Providence City Plan Commission

AGENDA ITEM 7 ■ 269 WICKENDEN STREET

OWNER/ APPLICANT:	Fox Point Capital LLC	PROJECT DESCRIPTION:	The applicant is requesting master plan approval to construct a five story mixed-use that will provide commercial space, internal parking and 62 residential units in the C-2 zone. The applicant is seeking a dimensional adjustment for the proposed height of five stories and approximately 65'. A design waiver from the height of window sills over 2' from grade is also requested.
CASE NO./ PROJECT TYPE:	23-021 MA Master Plan		
PROJECT LOCATION:	269 Wickenden Street C-2 zoning district AP 18 Lots 190 and 192	RECOMMENDATION:	Approval of the Master Plan subject to the noted findings
NEIGHBORHOOD:	Fox Point	PROJECT PLANNER:	Choyon Manjrekar

Building elevations

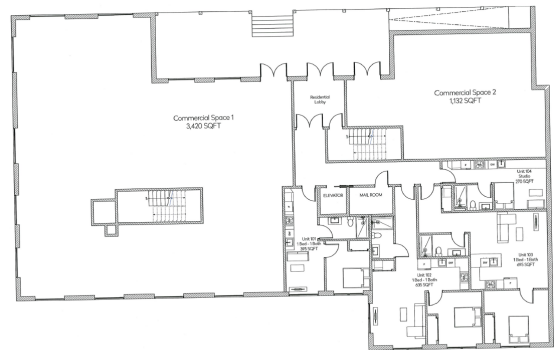
Due to the slope of the lot on Wickenden Street, the average grade is lower than the grade adjacent to the windowsills on the first floor, resulting in a height that's over two feet from the adjacent grade. Based on plans provided, the location of the sills is influenced by the slope of the lot and location of the adjacent grade, which accommodates a portion of the cellar. It is the DPD's opinion that the CPC should grant the design waiver as the bottom of the window

sills cannot be located within two feet of the adjacent grade due to the slope of the lot.

The CPC should vote to grant the design waiver for location of sills over two feet from adjacent grade, finding that it is required due to the grade of the lot.
